# MICROCHIP PIC16F631/677/685/687/689/690

## PIC16F631/677/685/687/689/690 Rev. A Silicon/Data Sheet Errata

The PIC16F631/677/685/687/689/690 parts you have received conform functionally to the Device Data Sheet (DS41262C), except for the anomalies described below.

**FIGURE 8-2: COMPARATOR C1 SIMPLIFIED BLOCK DIAGRAM**

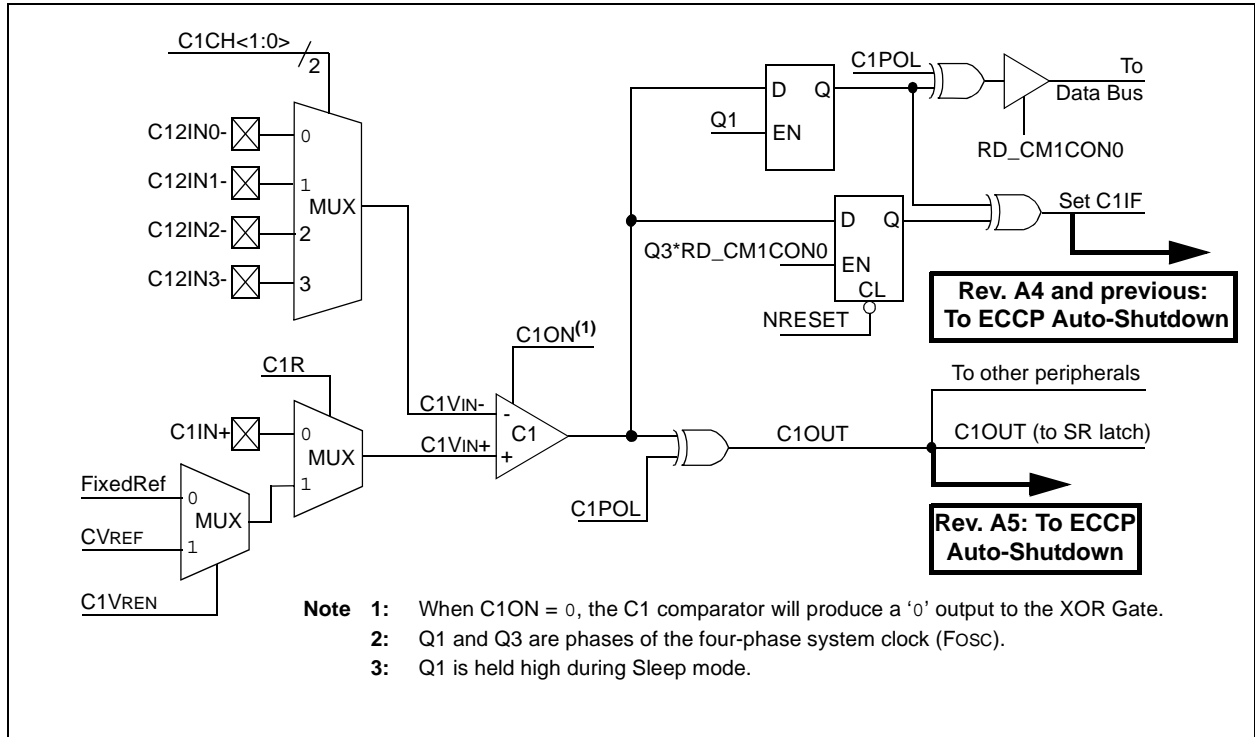
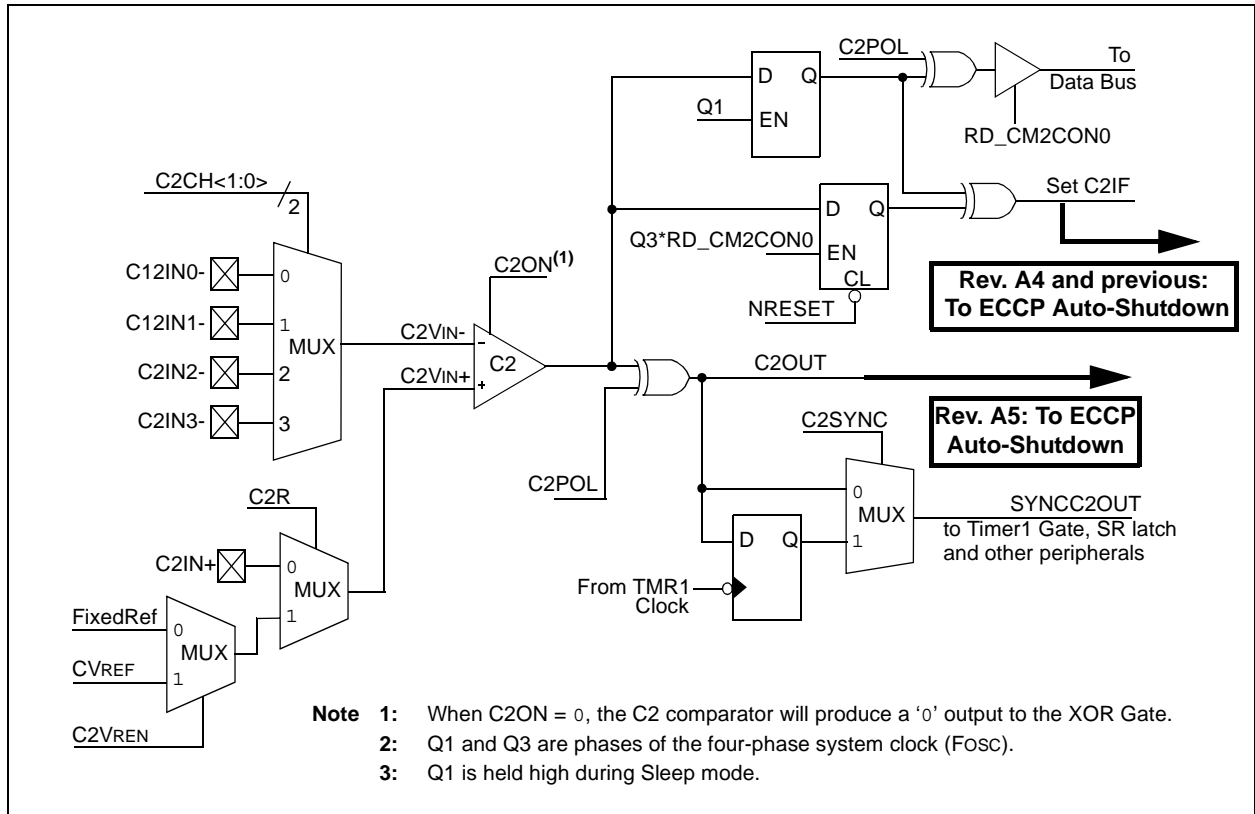
## 3. Module: ECCP with Auto-Shutdown (Silicon Rev. A4 and previous revisions) (PIC16F685 and PIC16F690 only)

The PIC16F631/677/685/687/689/690 Rev. A4 silicon for the ECCP Auto-Shutdown is connected to the C1IF and C2IF flags. See Figures 8-2 and 8-3 on the following page.

The auto-shutdown connection (Rev. A4 and previous) to C1IF and C2IF causes the auto-shutdown to incorrectly operate synchronously. Additionally, reads of CMxCON0 will incorrectly clear an auto-shutdown event.

- 1) Poll the CxOUT bit until it is low.
- 2) Read CMxCON0 to precondition CxIF.
- 3) If CMxCON0 is read while CxOUT is changing, repeat steps 1 and 2.

The Silicon Rev. A5 (now shipping) and later revision devices have moved the auto-shutdown connection from CxIF to CxOUT. This will eliminate the synchronous shutdown and simplify the use of the comparator for a shutdown event. Figure 1 shows the function of auto-shutdown before and after the device revision.
